V. ORLANDI

PRODUCT IMPROVEMENT NR.	01062013
PRODUCT	E50 / E50 PACIFIC / UN766

Photo (Old)

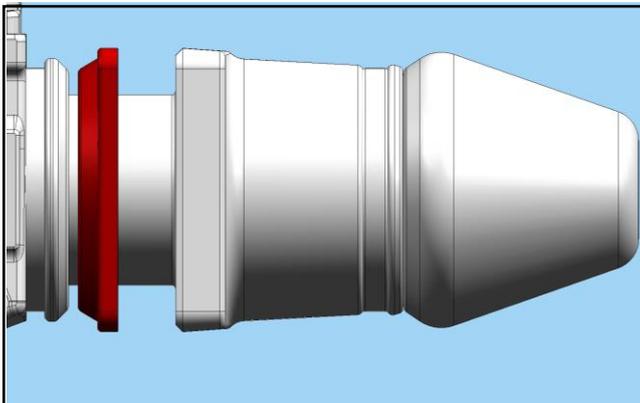
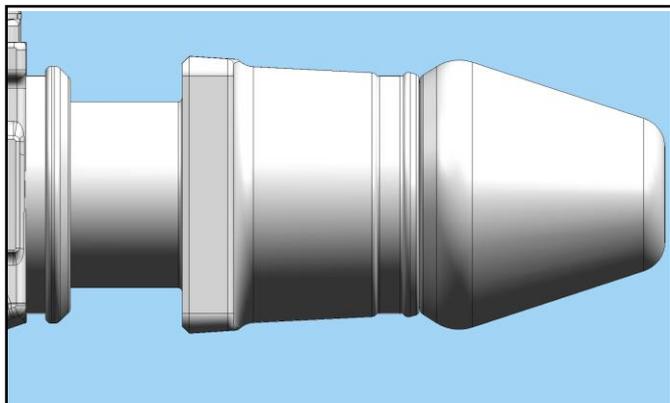
From the above picture the red colored front flange won't be part anymore of the below listed kit:

- RG00174 will become **RG00583** – to suits **E 506**
- RG00222 will be replaced by **RG00352** – to suits **E 509** and **UN76602**
- RG00373 will be replaced by **RG00372** – to suits **E 510**
- RG00424 will be replaced by **RG00423** – to suits **E 520 PACIFIC**

All the above mentioned kit will be supplied without the front flange.

From 1st of June the below products will be supplied without the front flange:

- E50 – **GE506A0/B0, GE509A0/B0, GE510A0/B0**
- E50 PACIFIC – **GE520A0/B0/E0/F0**
- UN766 – **UN76602**
